PERMITTED DESIGN

PERMIT REVISION

LEVEL R4/ G4

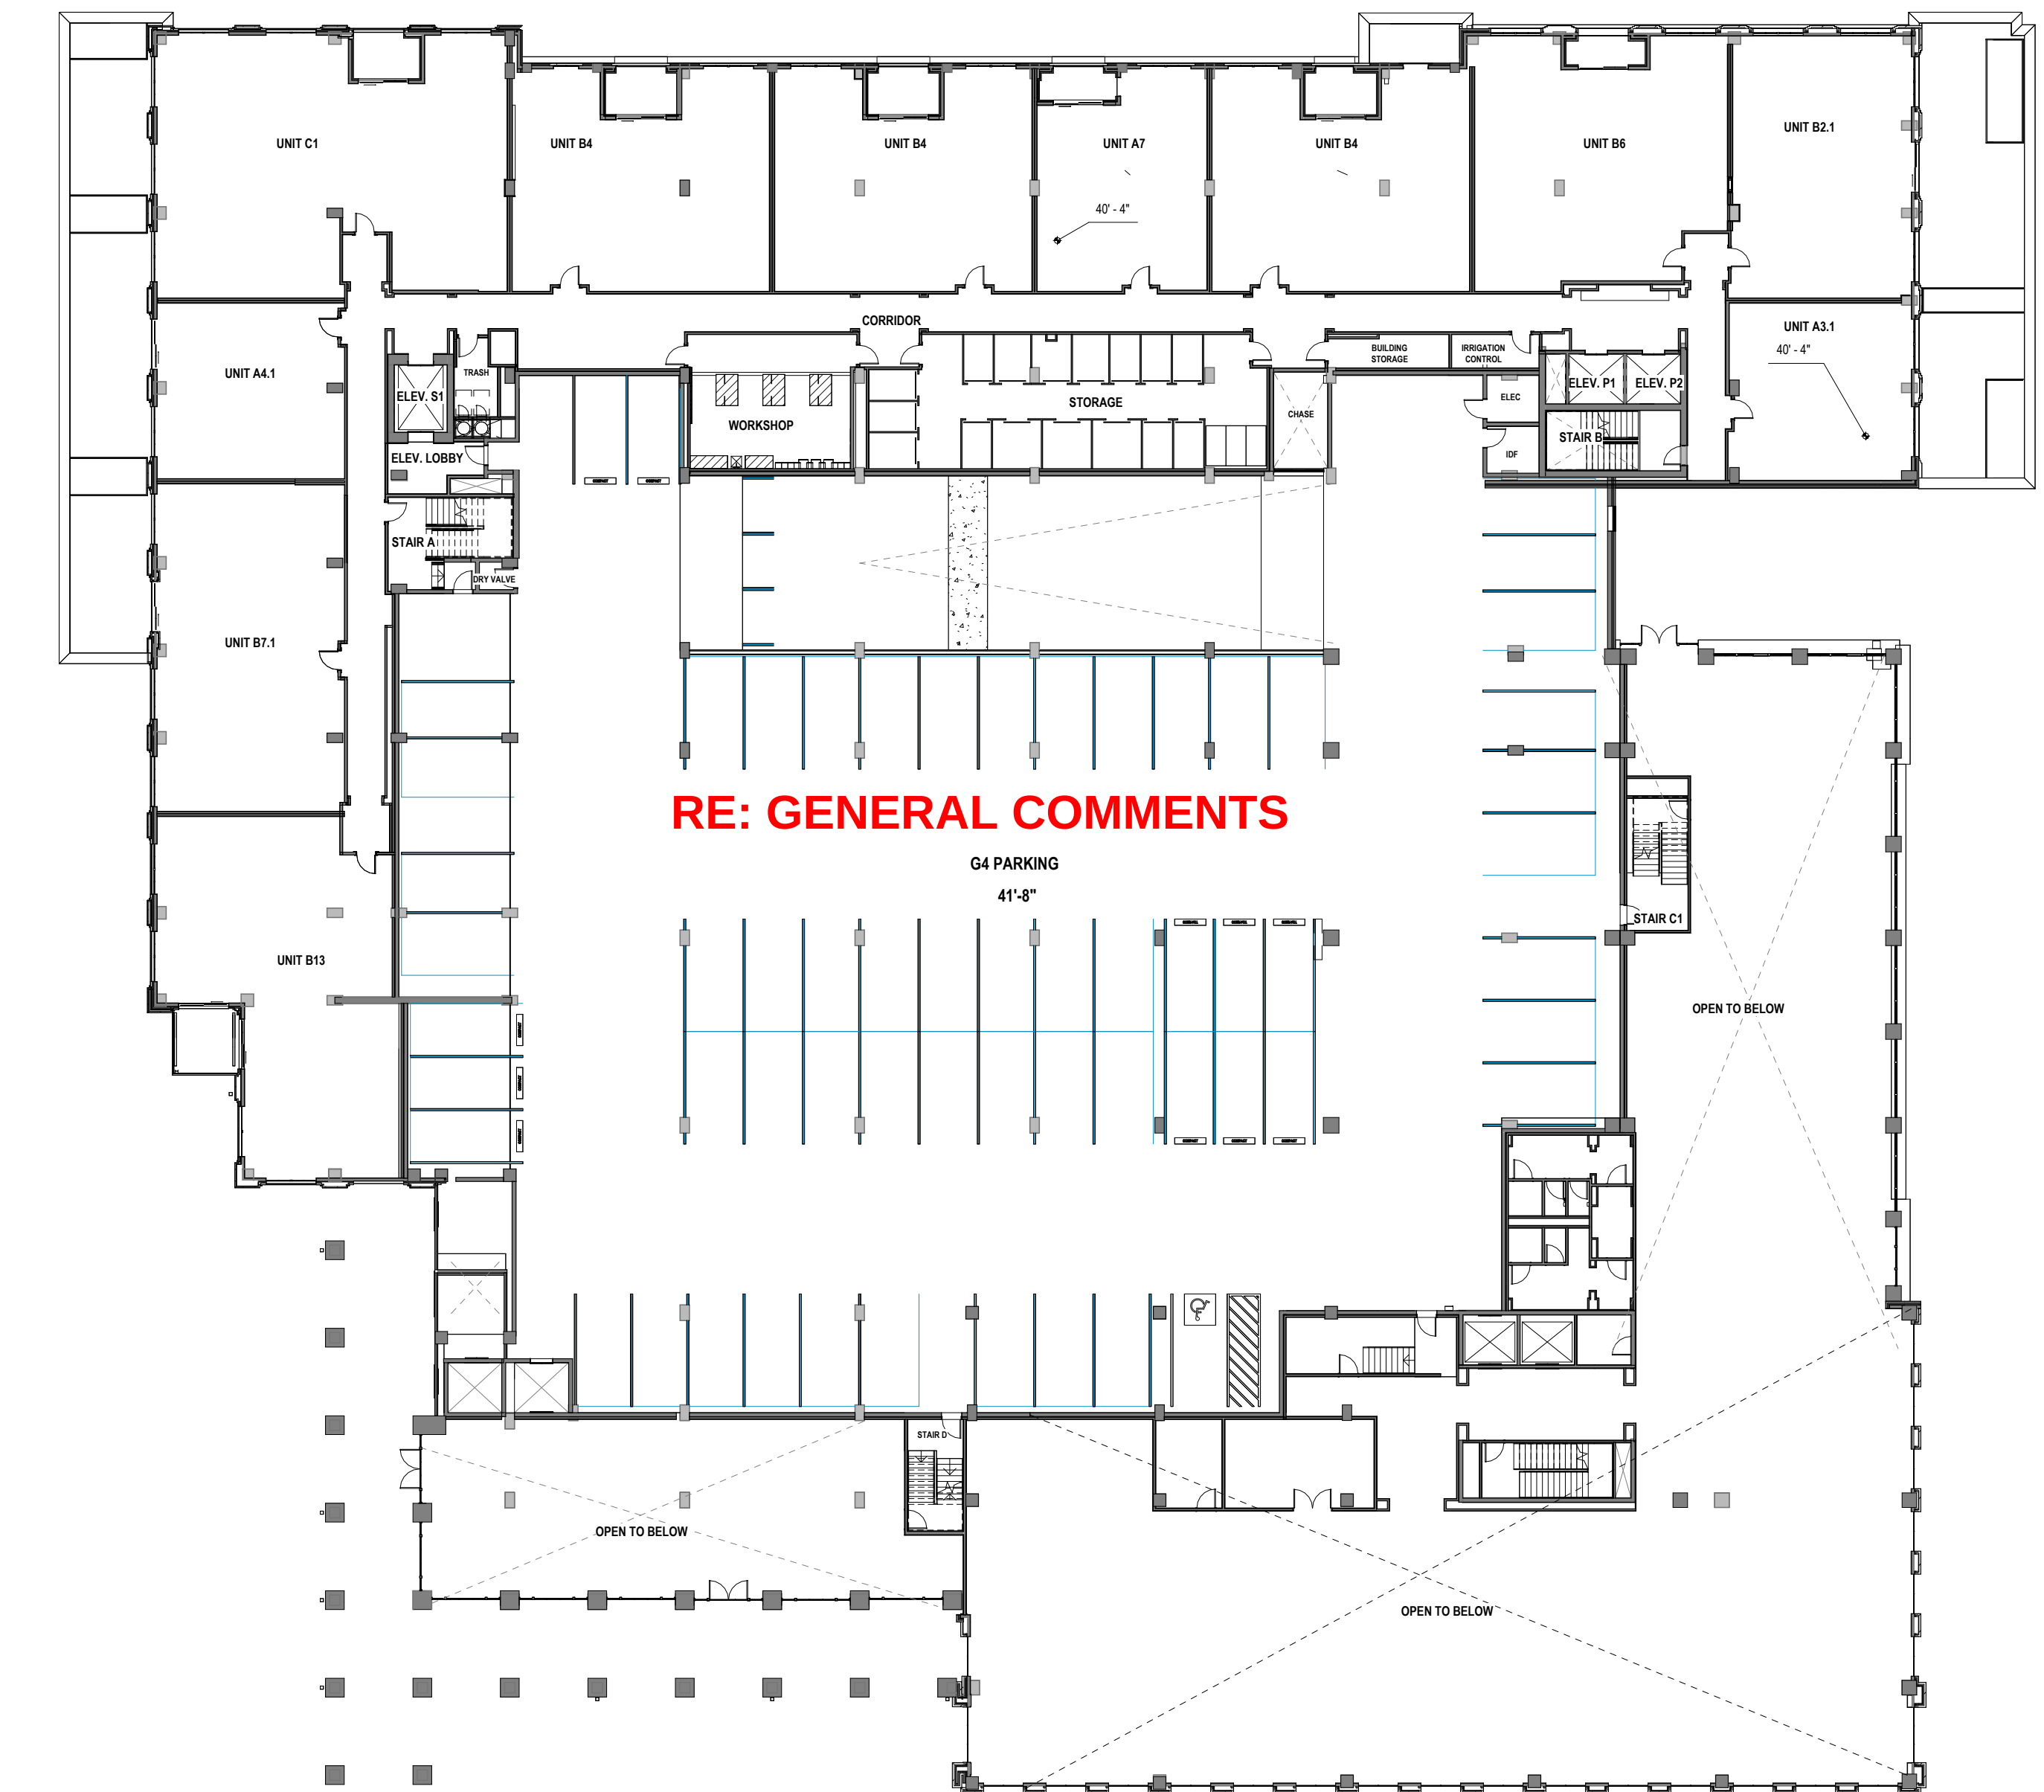
REVISIONS:

1. Reconfigured elevators. Removed (1) elevator.
2. Amenity level stair exit location moved.
3. Changed apartment units into office with dedicated office core (elevators, stairs, bathrooms, mechanical, and electrical). Added office terrace. Removed private garages.

General Comments:

- Level G3B (parking) was added between Level 3 and Level 4.
- Residential and office is split between Level C4/ G3B and Level R4/G4/

LEVEL 5

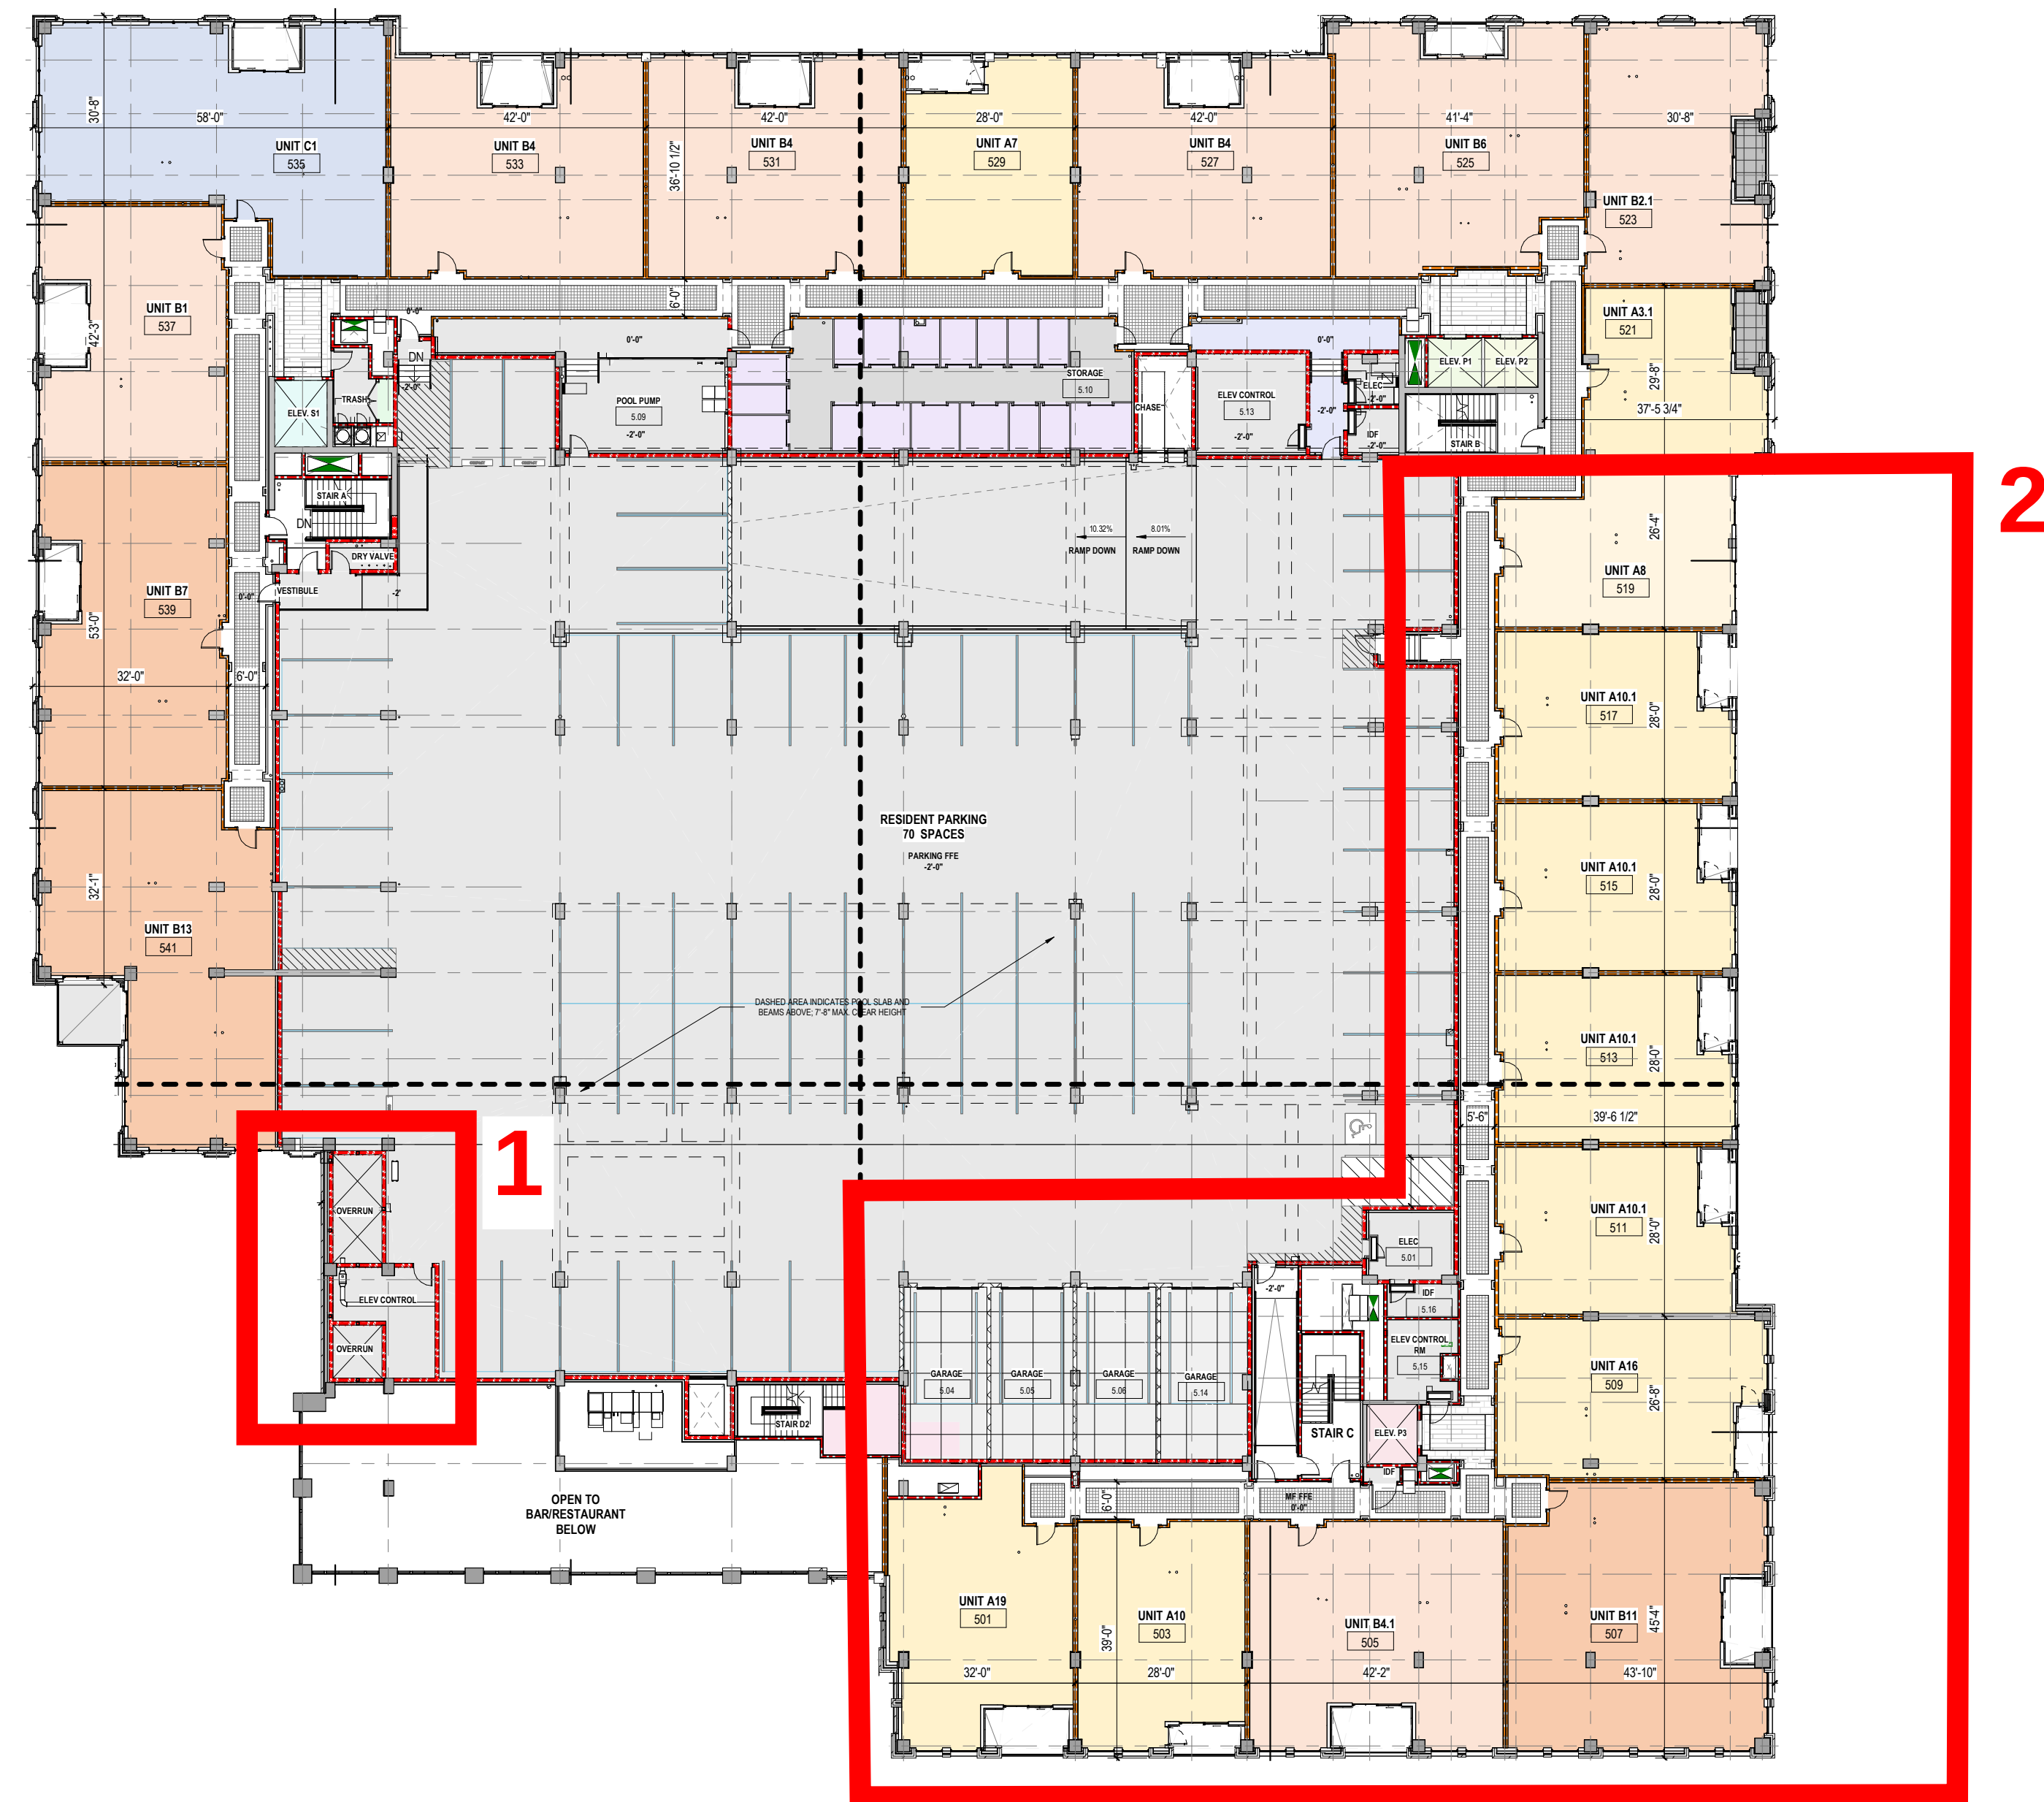
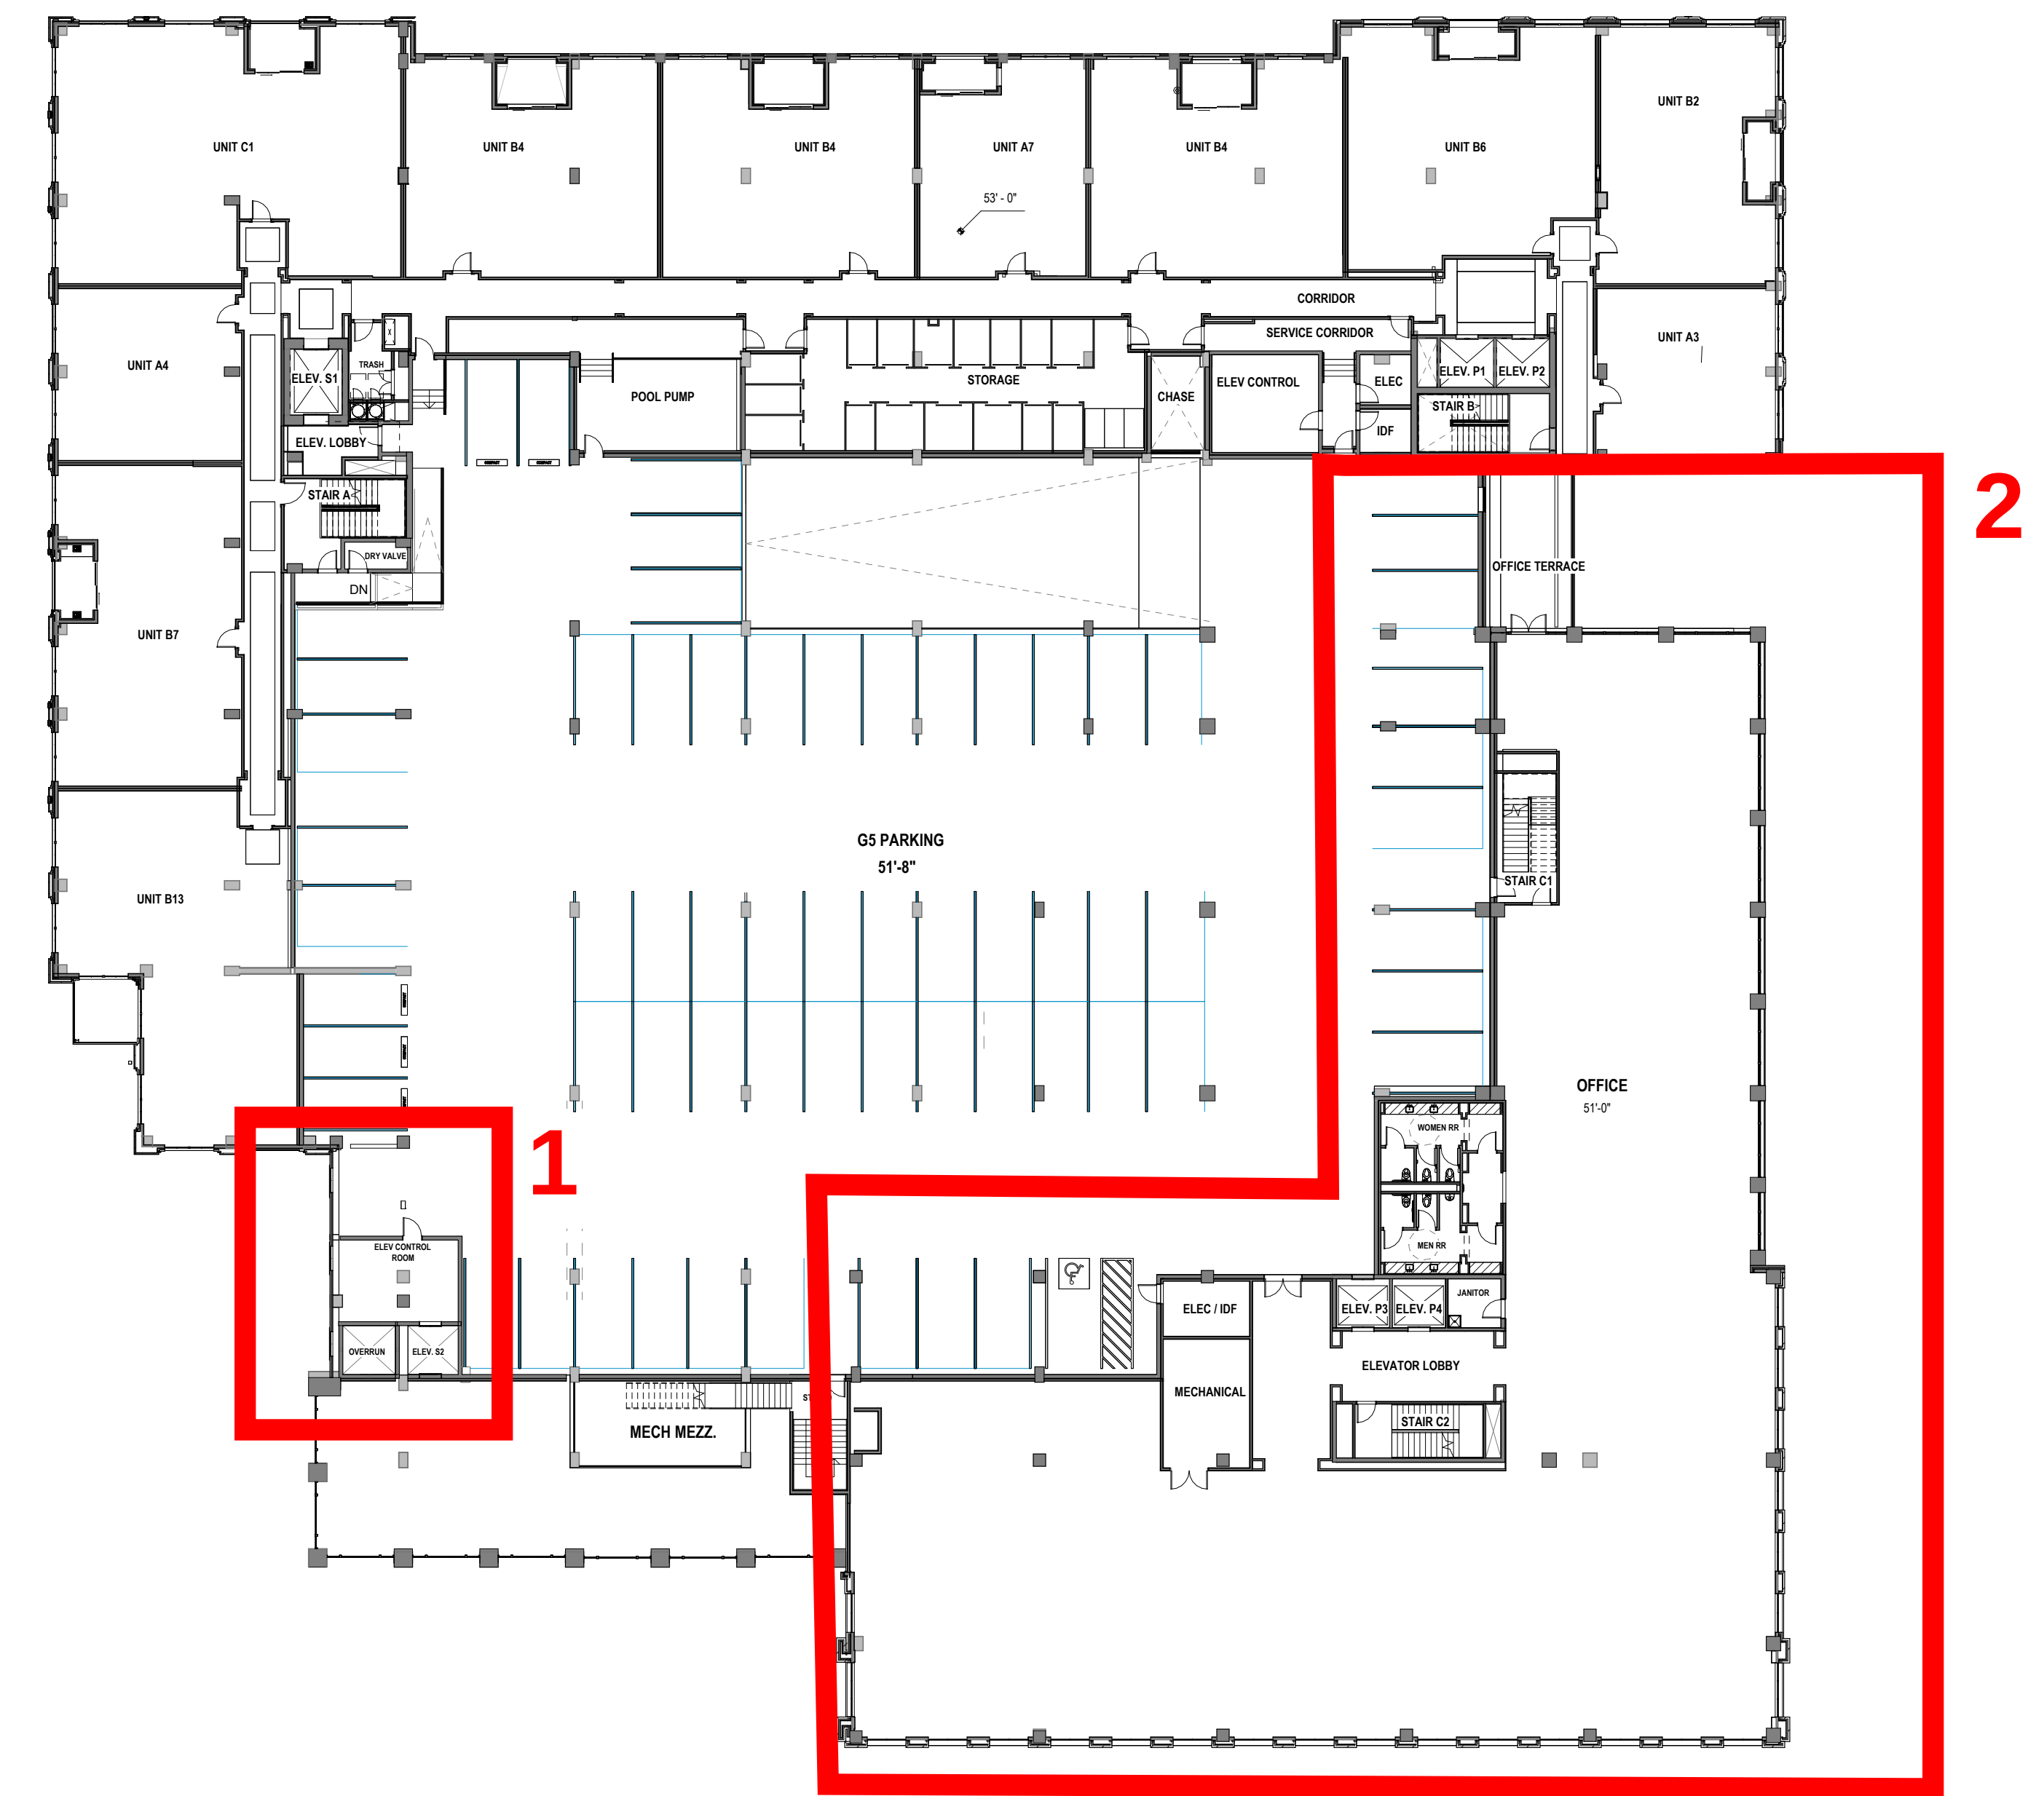
REVISIONS:

1. Reconfigured elevators. Removed (1) elevator.
2. Changed apartment units into office with dedicated office core (elevators, stairs, bathrooms, mechanical, and electrical). Added office terrace. Removed private garages.
